RHODE ISLAND CONTRACT NO. 2006-CH-072

**Improvements To Interstate Route 195 Interim Shoring South Water Street On Ramp Bridge No. 524**

ADDENDUM NO. 3

**IMPROVEMENTS TO INTERSTATE ROUTE 195**  
 INTERIM SHORING  
 SOUTH WATER STREET ON RAMP  
 PROVIDENCE RHODE ISLAND  
**GENERAL DETAILS** 14

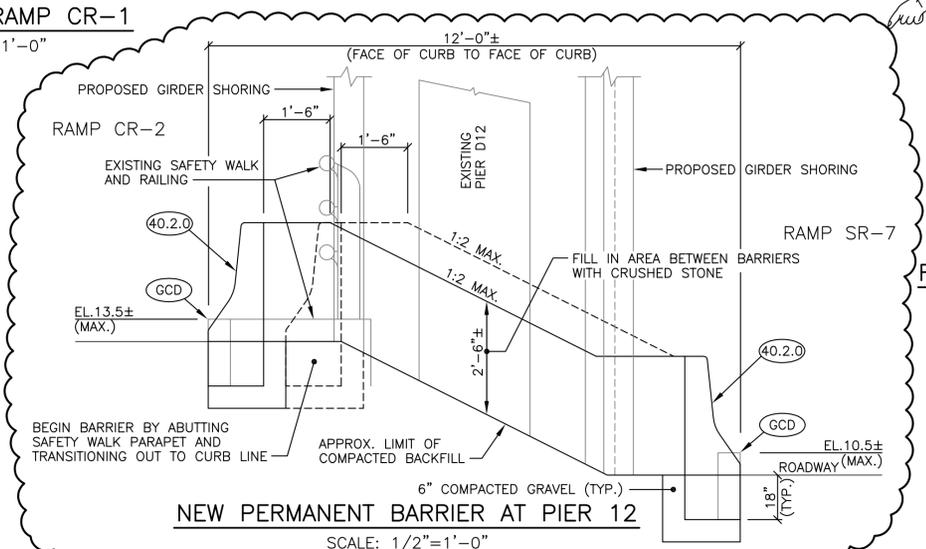
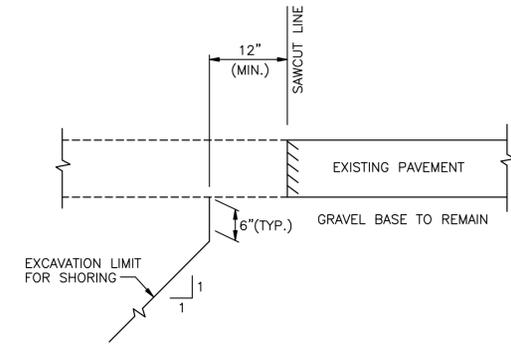
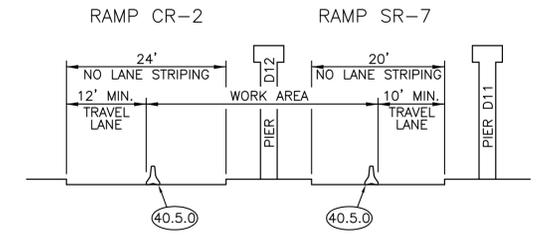
Delete General Details in its entirety and insert revised General Details attached to this Addendum. The Typical Section Thru Ramp CR-2, SR-7 and SR-5 has been revised. The Section Thru Ramp CR-1 and Section A-A have been revised and a new detail for the New Permanent Barrier at Pier 12 has been added.

**IMPROVEMENTS TO INTERSTATE ROUTE 195**  
 INTERIM SHORING  
 SOUTH WATER STREET ON RAMP  
**PROVIDENCE** **RHODE ISLAND**  
**TRAFFIC CONTROL PLAN NO. 1**  
**RAMP CR-1** **15**

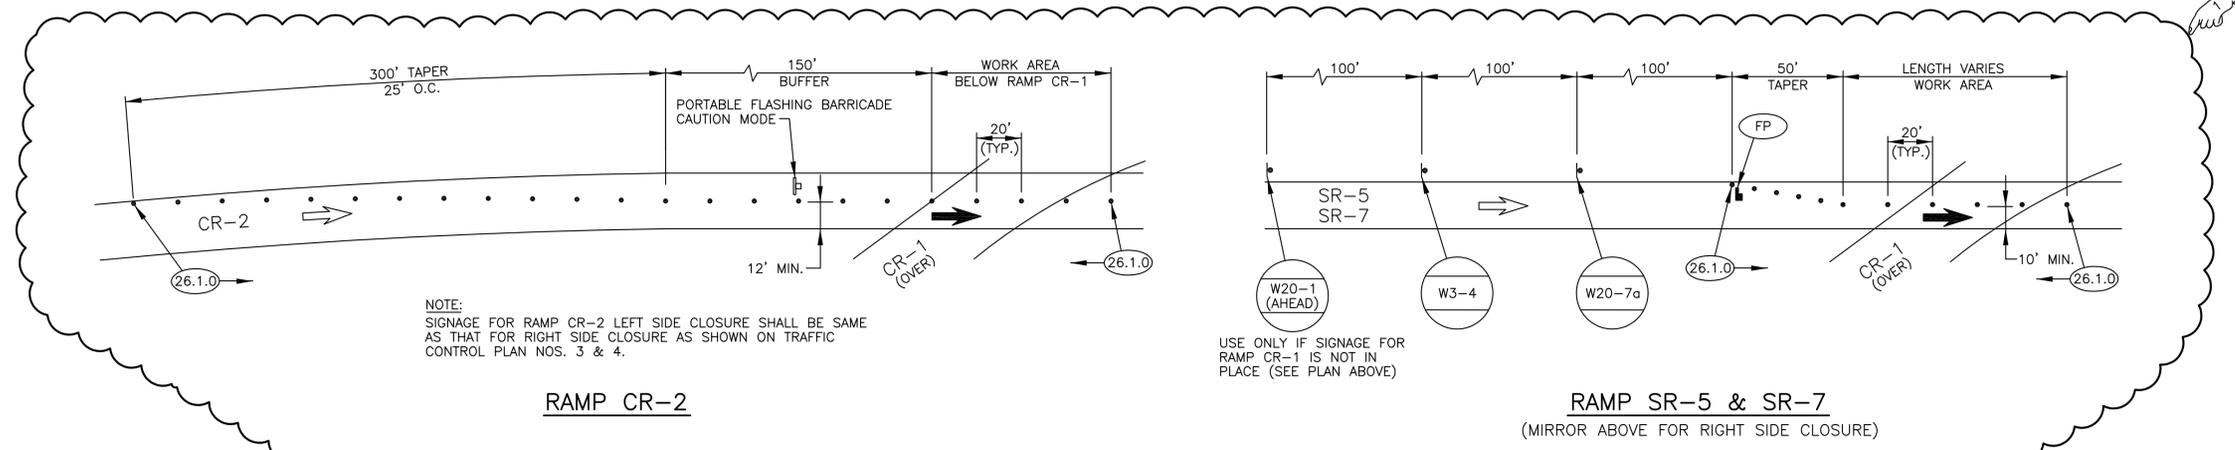
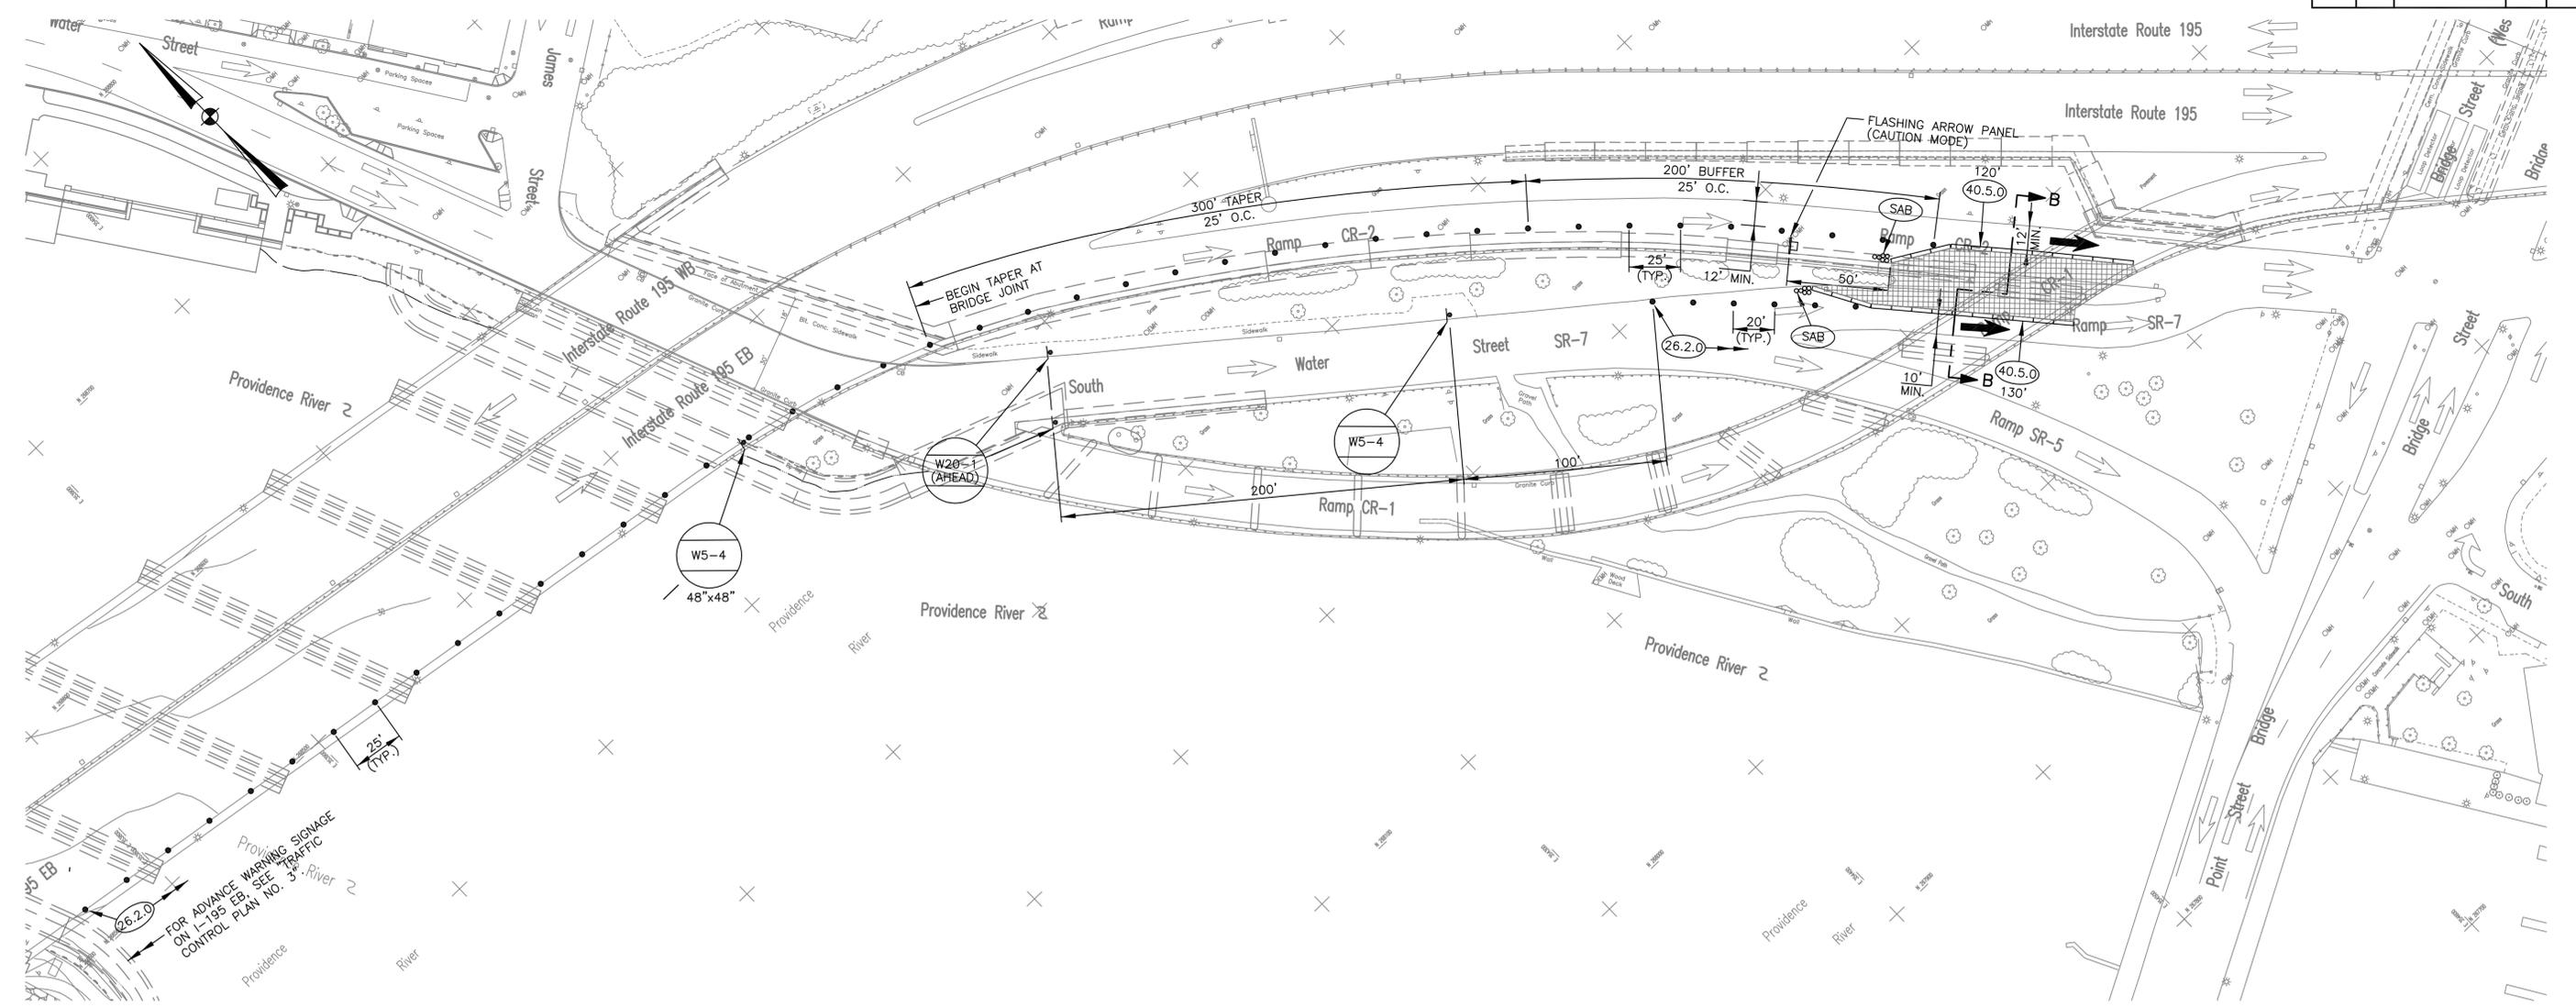
Delete Traffic Control Plan No. 1 Ramp CR-1 in its entirety and insert revised Traffic Control Plan No. 1 Ramp CR-1 attached to this Addendum. The dimensions associated with the Permanent Right Side Closure on Ramp CR-1 have been revised and also new details for Temporary Left or Right Side Ramp Closures have been added.
